Product Change Notice (PCN)

PCN Number: PCN-0454905R-01

Product(s) Affected: *PJ-079BH*

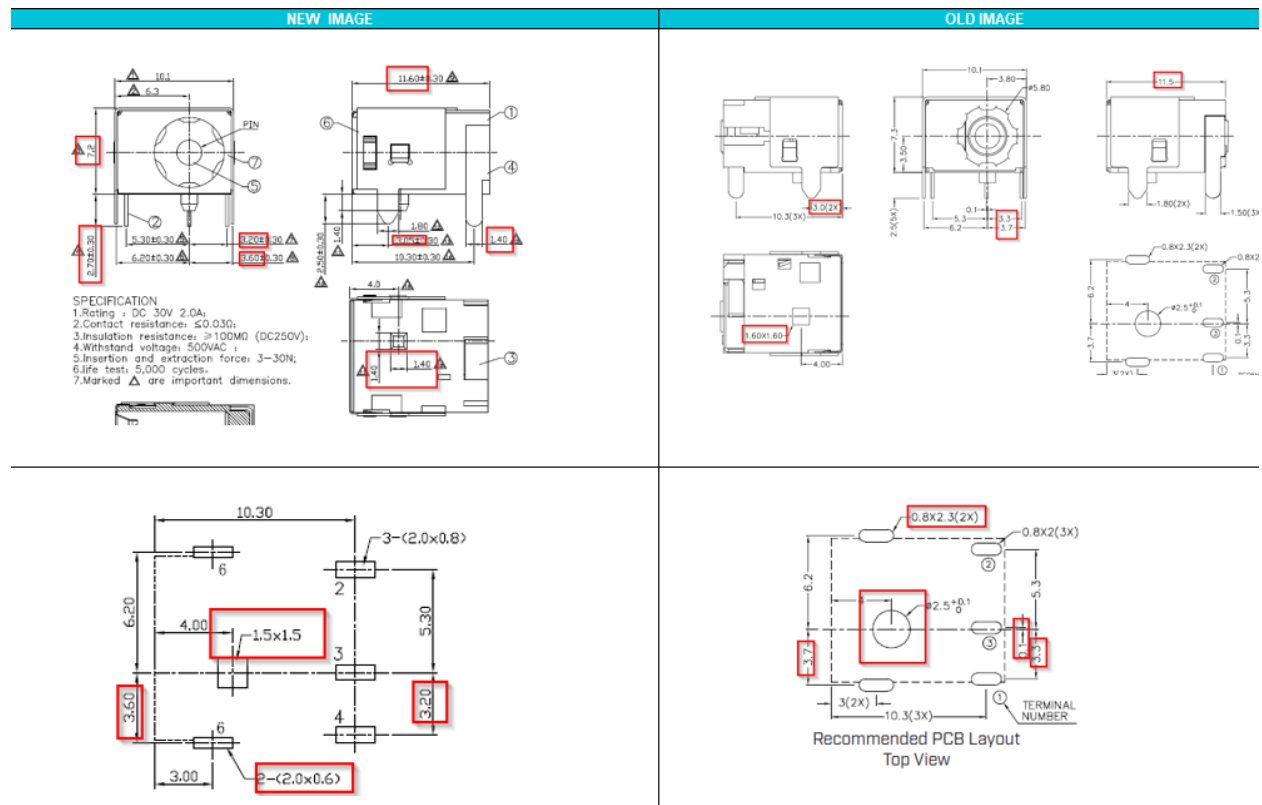
Description of Change: *Minor Housing and footprint differences. Material Change on the housing and terminals. See image Below*

Housing and Terminal Material Changes:

Center Pin: Copper to Brass
Terminal 2: Copper Alloy to Brass
Plastic: PA6T or Equivalent to PA9T
